RE: Mountain Valley Pipeline - Review of June 1, 2017 Submittal in Response to Request for Information

Mountain Valley Pipeline

DEQ Review Comments - Request for Additional Information

Areas of significant karst development potentially impacted by the MVP Pipeline

Figure 1. Kow Camp Karst

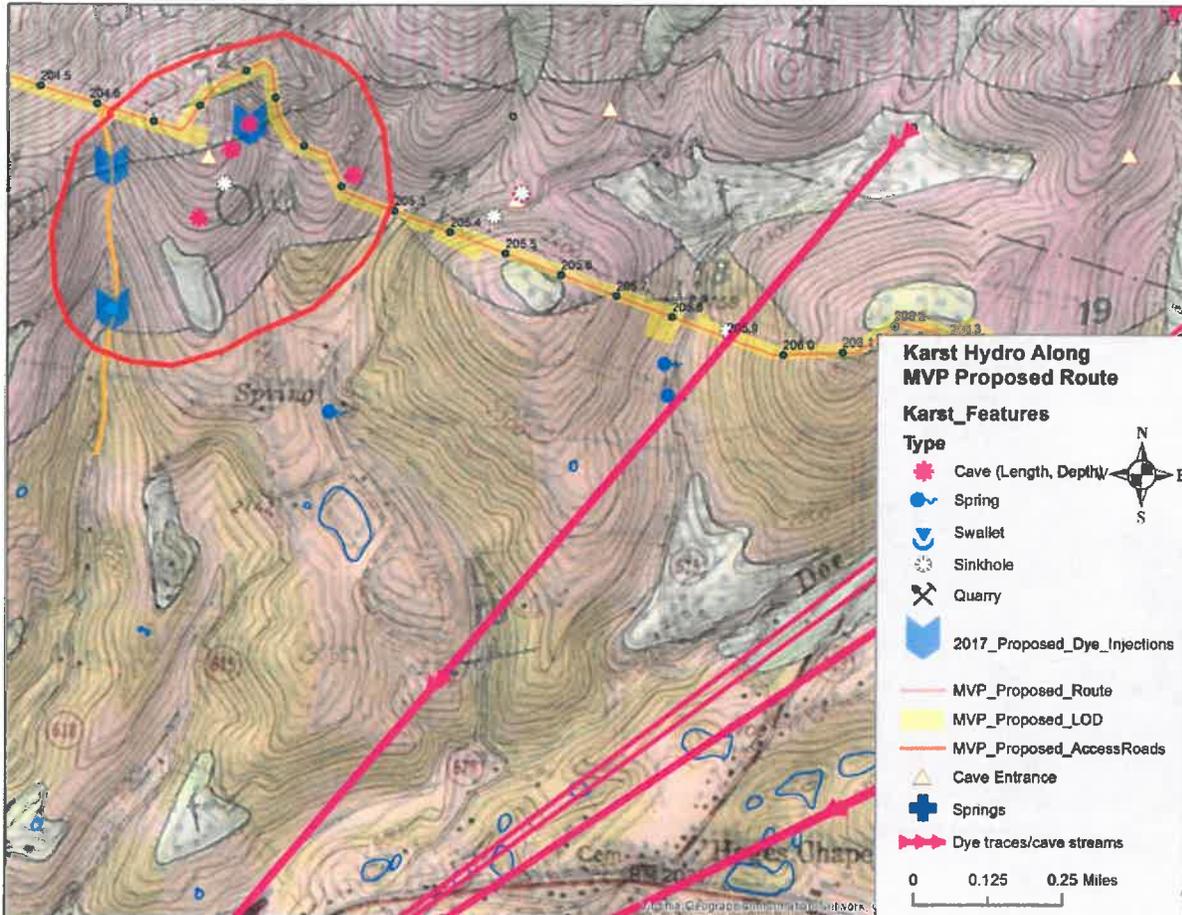
*Kow Camp Karst (204.6 – 205.5) – Dye trace needed

In this area, the corridor passes north (upstream) of some caves and sinkholes (see Figure 1.) One cave, 8 Second Cave, lies within a drainageway and receives direct runoff from the corridor. Note that the potential for discharge is low, especially since the lies at or near the drainage divide northwest of the cave. 8 Second pit likely goes deep quickly, with the water resurging at either the Rise of Doe Creek or Klotz Spring. In addition, the access road joining the corridor at ~ MP 204.6 runs up a steep drainage crossing the middle Ordovician limestones. This drainageway should be reviewed carefully for stream sinkpoints. If there are stream sinkpoints they should be traced. Accidents resulting in discharges of sediment or contaminants are at least as likely along access roads as in the corridor itself.

Figure 2. Sinking Creek - Doe Creek Transition

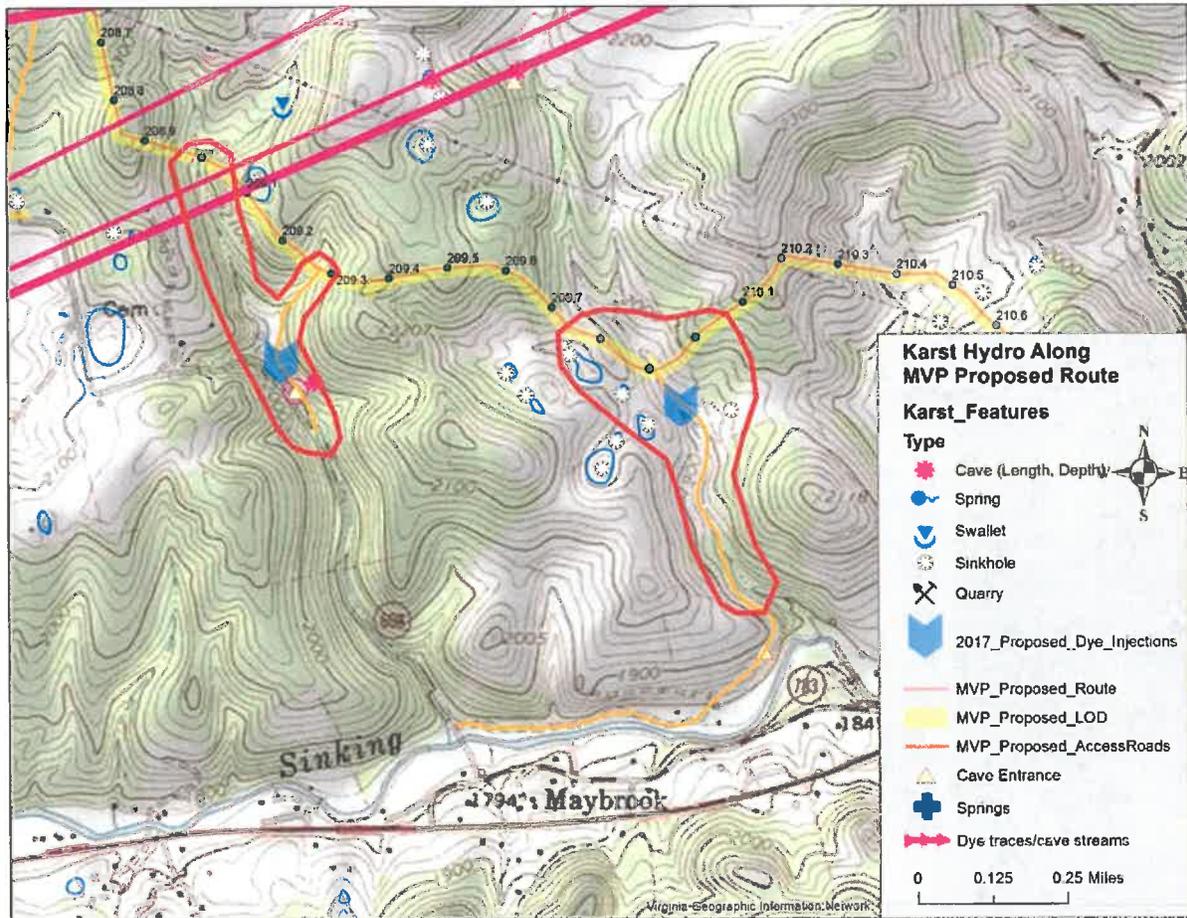
*Sinking Creek-Doe Creek Transition (208.2 – 211) – Dye trace may be needed

This area is underdrained by documented flow paths to the rise of Sinking Creek and/or Doe Creek. However, karst features on surface may also discharge to Sinking Creek upstream of its sinkpoint. Two sensitive areas, mp 208.9-209.3 and 209.75 – 210.05, cross steep channels cut into limestone and dolomite that are likely to have sink points (see Figure 2.) It should be determined whether any sinkpoints exist along these drainageways downslope of the corridor. If they do, these should be dye traced to determine whether they resurge at the New River, or at springs along Sinking Creek upstream of its sinkpoint.

Figure 3. Karst along north slope of Sinking Creek Mountain, MVP

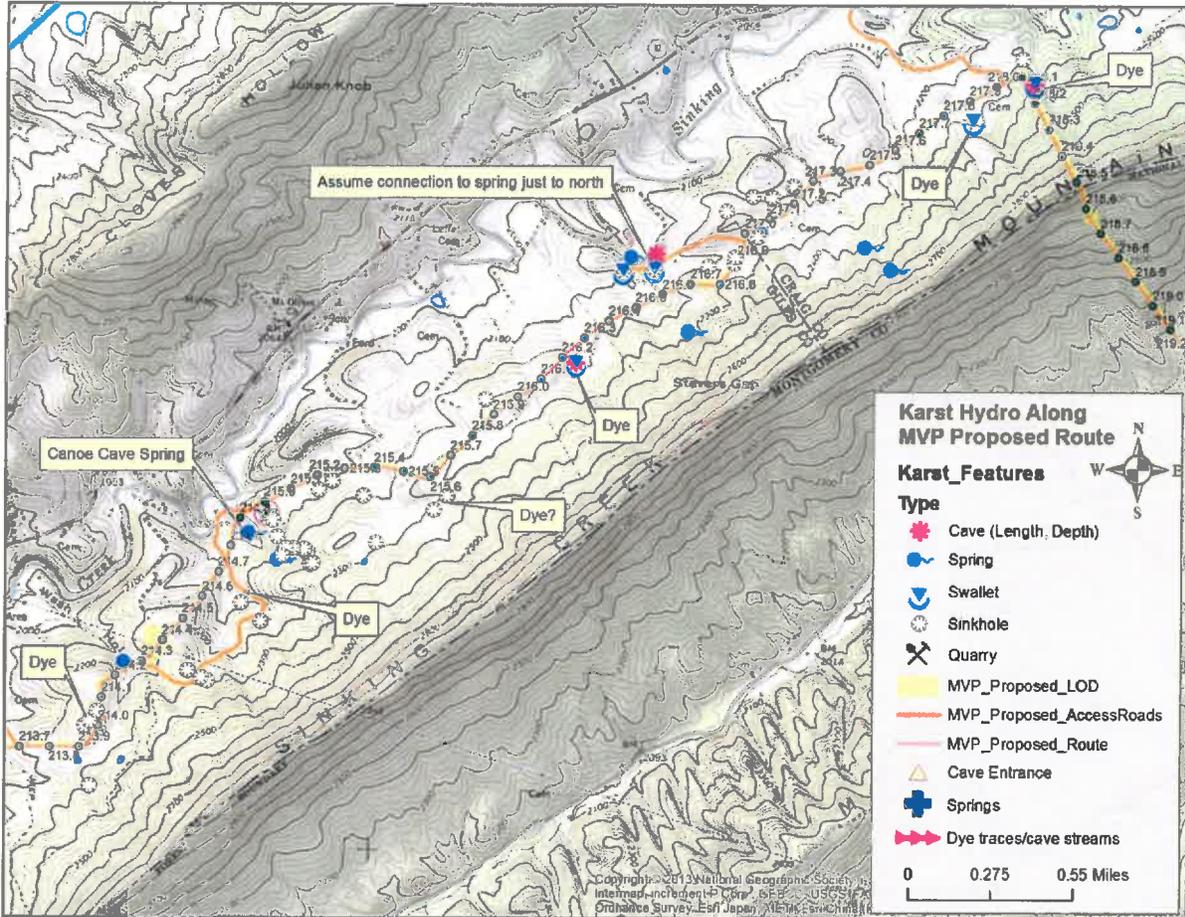
*Sinking Creek Mountain (213.7 – 218.5) – Dye tracing recommended

Multiple sinkholes, sinking streams, springs and a significant cave all lie along this stretch. “Moderate potential for impact” swallet and cave entrance identified at eastern end of section at base of Sinking Creek Mountain, and a “moderate potential for impact” to a spring is indicated at MP 214.26. Tracing should be performed to determine resurgence and recharge for these features, and spring basin divides along the flank of the mountain, including Canoe Cave spring. See Figure 3. Sufficient data to delineate would require 2-3 rounds of tracing, injecting dye into 4-6 features total.

Figure 4. Mill Creek Divides Karst

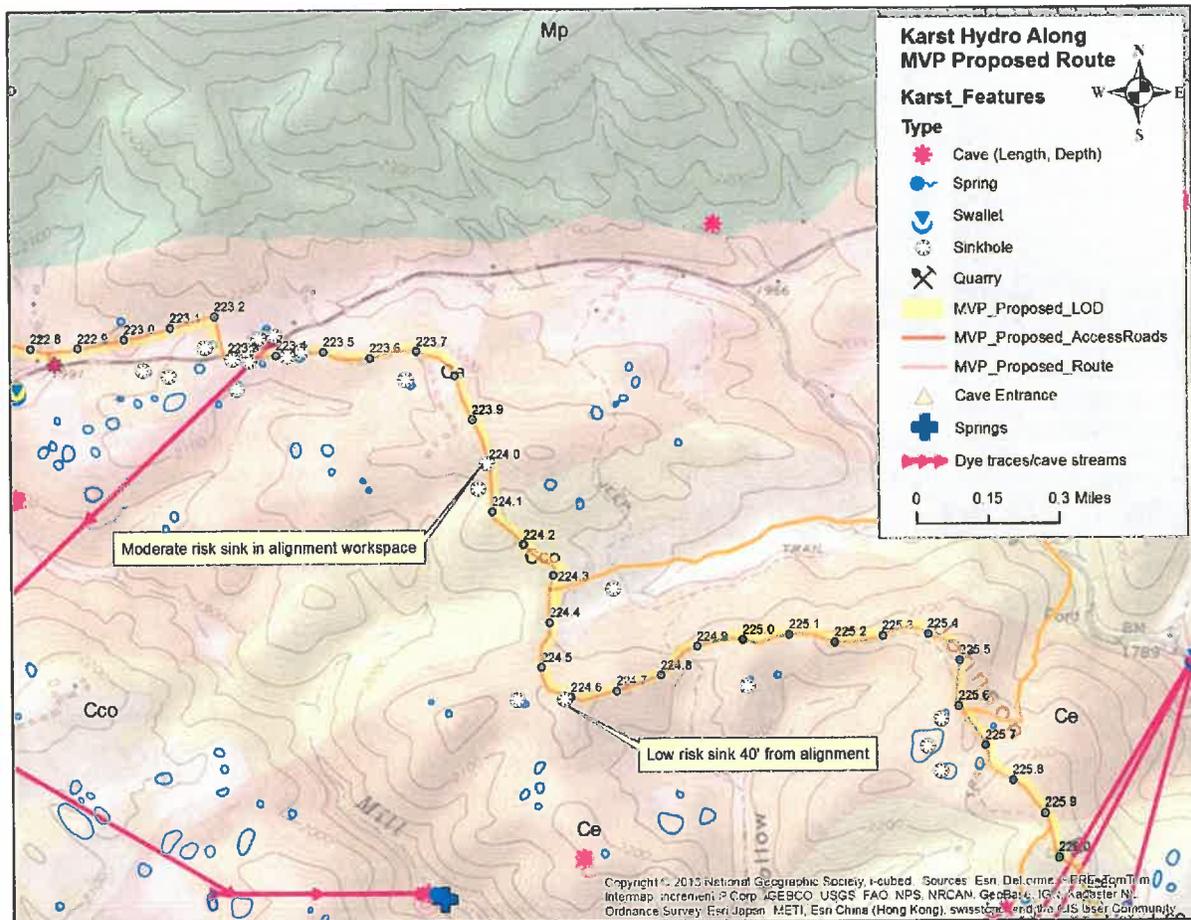
*Mill Creek Divides Karst (223.6 through 225.5) – Additional dye tracing recommended

Specific resurgences are not defined for karst features in this area. Features in the northern end may drain to Slussers Chapel Cave and Mill Creek Spring, or to small springs along the Mill Creek Valley. Eastern extent probably goes to Old Mill Cave and spring, either directly or via resurgence on Dry Run. There are only 2 documented sensitive karst features in this area. The feature at mp 224 considered moderate potential. DCR recommends dye tracing of this feature, and the second feature as well if determined practicable.

Figure 5. Johnson Ridge Karst

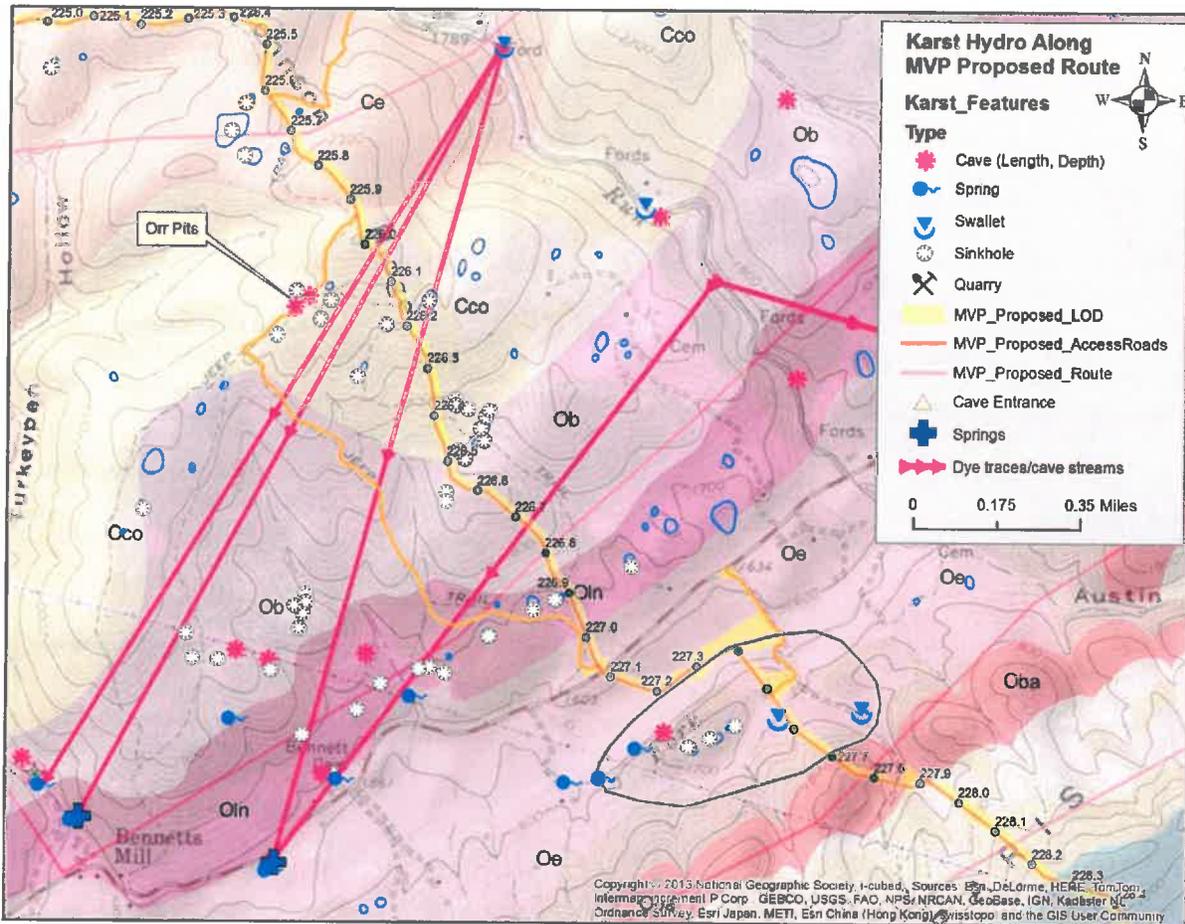
Orr Pits and Johnson Ridge Karst (225.5 – 227) – Existing knowledge sufficient

Any discharge into sensitive features along this stretch of the corridor would resurge at either Old Mill Cave (aka Salmon) Spring or a spring on the Slusser and Grice Farm property (see Figure 5.)

Figure 6. Johnsons Cave Karst

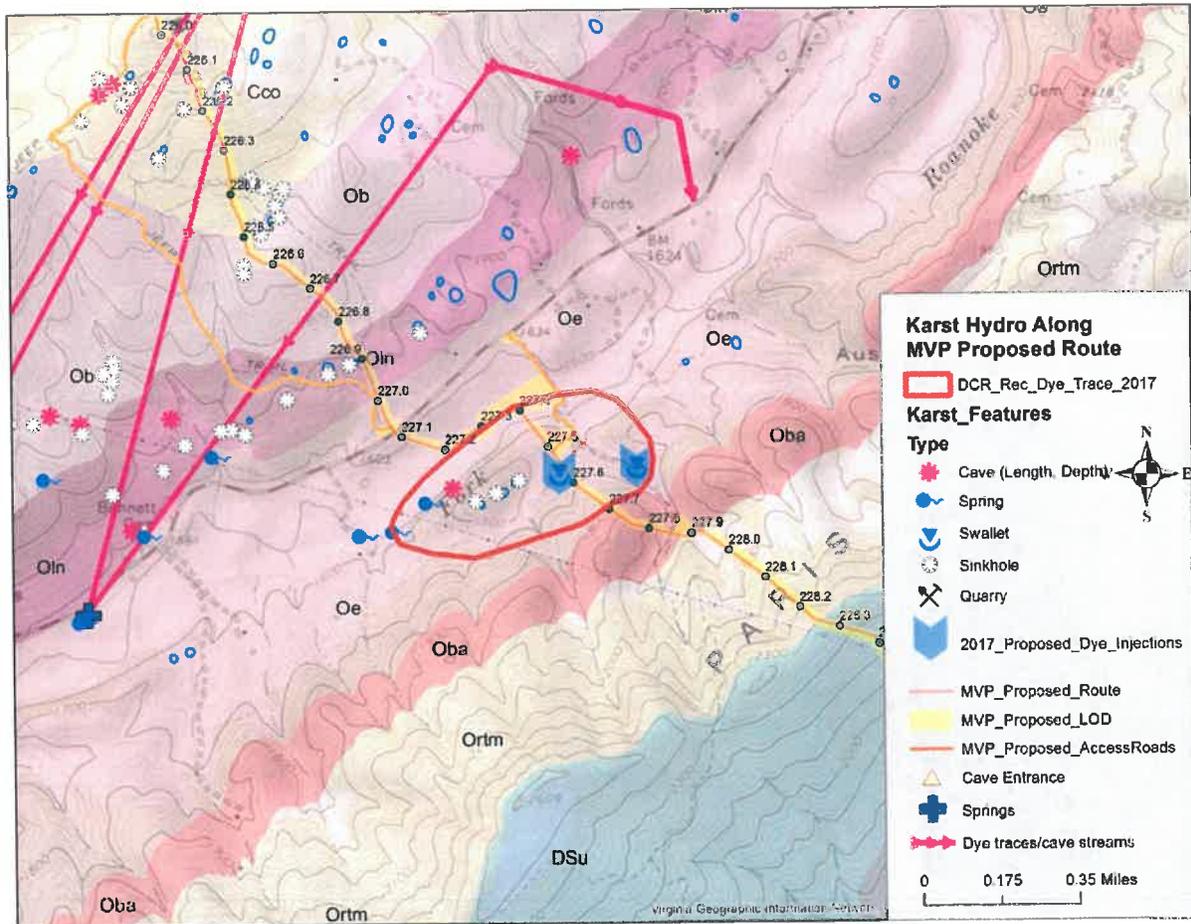
***Johnsons Cave Karst, Montgomery County (227.23 – 227.70) – Dye tracing recommended**

These features most likely all connect to Johnsons Spring and Cave system. DCR karst recommends dye tracing losing stream at 227.57 to verify this connection. If dye tracing not performed, the Spill Prevention Control and Countermeasures Plan needs to specify both 1) Johnson Spring and 2) the confluence of the North Fork of the Roanoke River with intermittent channels draining the northwestern slopes of Paris Mountain as spill recovery locations.
